**RESPONSE TO REQUEST FOR ADDITIONAL INFORMATION**

**SAFETY SYSTEM DIGITAL PLATFORM  
- MELTAC (MITSUBISHI ELECTRIC TOTAL ADVANCED CONTROLLER) -  
TOPICAL REPORT**

**Mitsubishi Electric Corporation**

**TAC NO.:** MF4228  
**RAI NO.:** #1  
**DATE OF RAI ISSUE:** 6/29/2016

Figure 1 Reliability Model of a Single Controller

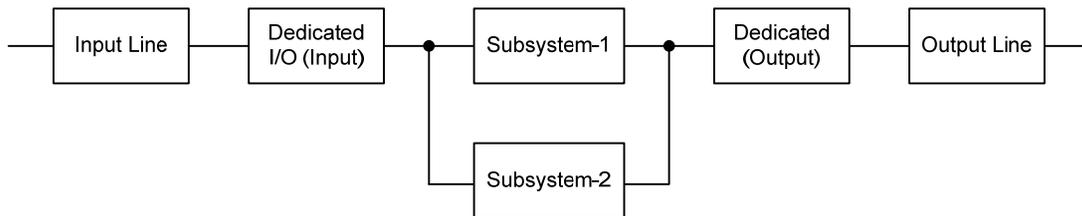
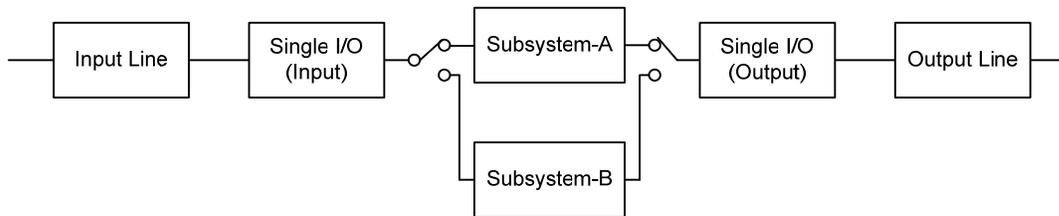
Page 214 of the TR discusses the generic redundant parallel controller reliability analysis and a fault tree analysis to support that controller configuration review. The NRC staff needs to review this specific analysis and additional analyses for other controller configurations and modules that are included in the MELCO platform to complete its evaluation in accordance with ISG-06 Section D.9.4.2.1.1. Please provide a description of the criteria used to determine which controller configuration will be used (i.e. single, redundant parallel or redundant standby) as well as documentation to demonstrate compliance of other possible controller configurations to this criteria.

Section 7.2, "Controller Reliability Analysis" pertains to frequency of failures for the three controller configurations that can be applied with MELTAC. These are single, redundant parallel, and redundant standby (described in Section 4.1.1). Among these configurations, the configuration that can satisfy the plant specific reliability requirements is applied, with consideration of both actuation assurance and spurious actuation prevention. The actual reliability calculations are in plant specific documentation. The reliability models shown in Section 7.2 are intended to only show the reliability analysis method for each of the three basic controller configurations. The reliability models of these configurations are shown in Figure 1, Figure 2 and Figure 3, respectively.

Each configuration has one input module and one output module as a single I/O module. Redundant I/O modules can also be applied, as described in Section 4.1.1; for simplicity, these reliability models show only single I/O modules.
